City Council Agenda Items
and
Contracts, Leases or Agreements

ADM 11-4018: (CHAPTER 172: PARKING AND LOADING AMENDMENTS): Submitted by Staff to repeal and replace section 172.10: Bicycle Parking Rack Requirements of the Unified Development Code.

Subject: ADM 11-4018 UDC Amendment Chapter 172.10 Bicycle Parking Rack Requirements

AN ORDINANCE TO REPEAL §172.10 BICYCLE PARKING RACK REQUIREMENTS OF THE UNIFIED DEVELOPMENT CODE AND TO ENACT A REPLACEMENT §172.10

Figure 1

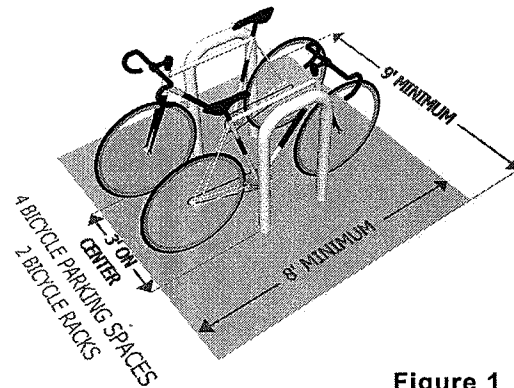
- (1) *Spacing between bicycle racks.* Each bicycle parking space shall have 36" of clear space, paved or unpaved, beside the rack allowing each rack to

support two bicycles. The 36" dimension may overlap another bicycle parking space such that racks positioned in a parallel row may be 36" on center. The minimum length dimension required is 8' free and clear (See: Figure 1).

Figure 2

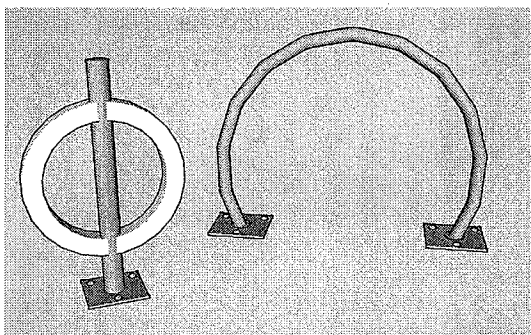
(E) *Bicycle Rack Specifications.* The Planning Division has pre-approved the standard inverted u-shaped bicycle rack (see figure 1). Applicants may also request an alternative design with Planning Division approval (see examples in figure 2). All bicycle racks shall be designed so that they support a bicycle at two points on the bicycle frame and such that the bicycle may be securely locked with a u-shaped bicycle lock (See figure 3).

Figure 1. Two racks spaced 2 feet 6 inches on center and equaling 4 parking spaces.

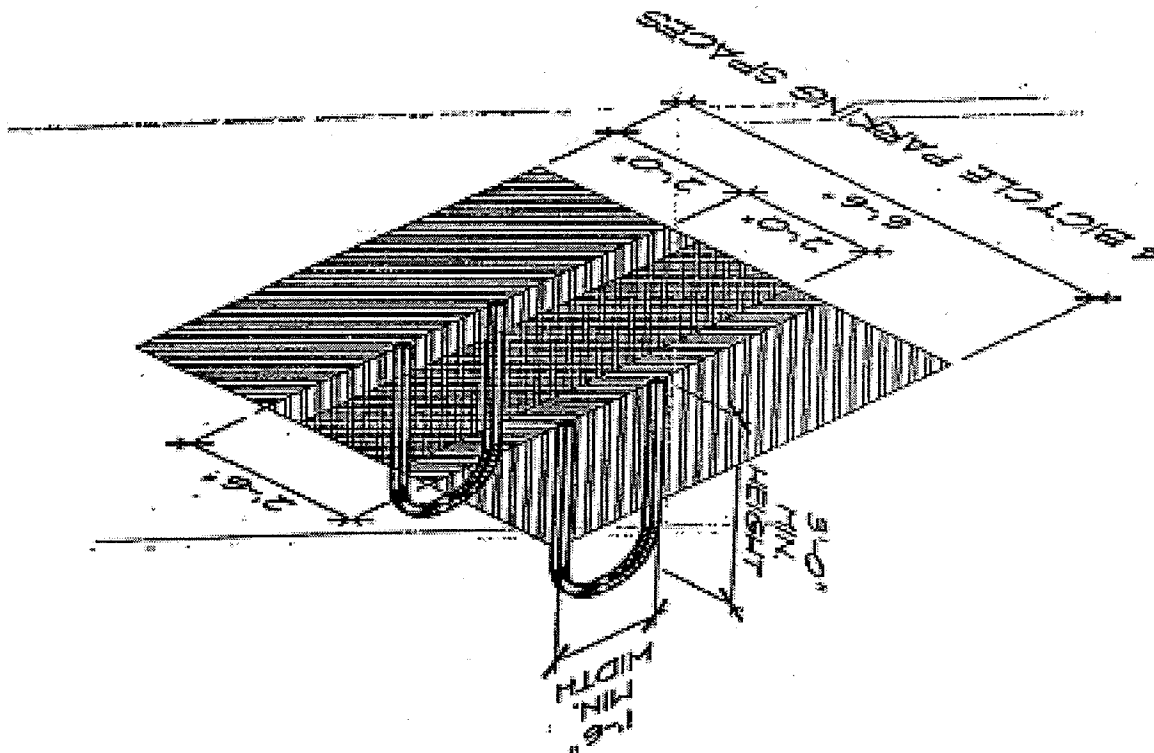
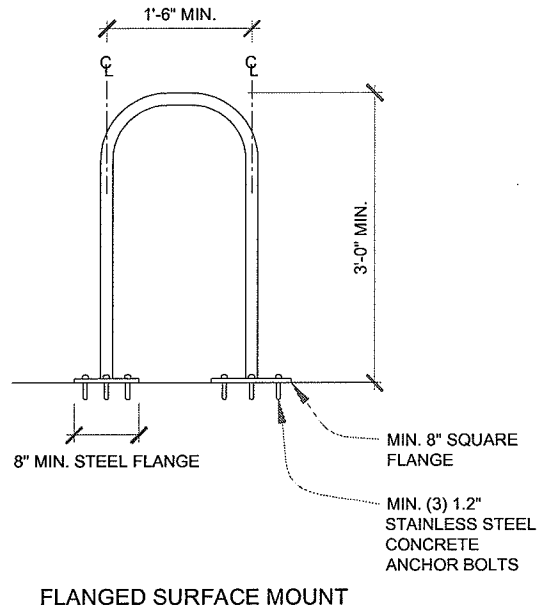
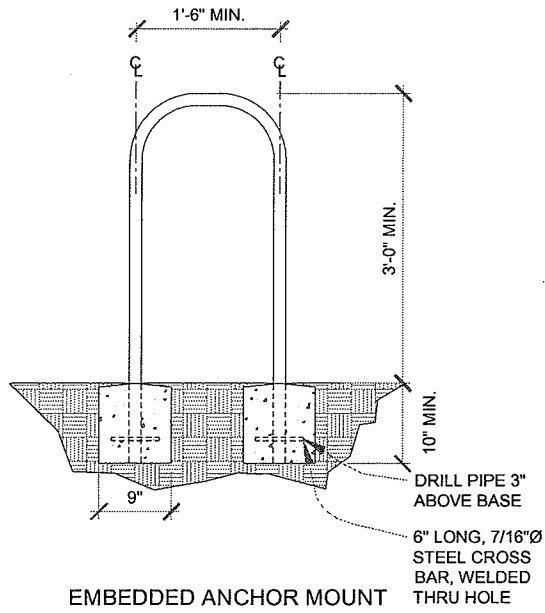
~~(D) Spacing of racks. Each bicycle parking space shall have 2' 0" x 6' x 0" clear space, paved or unpaved, beside the rack allowing each rack to potentially count as two spaces. The 2' 0" dimension may overlap another bicycle parking space such that racks positioned in a parallel row may be 2' 6" on center (See: Figure 1).~~
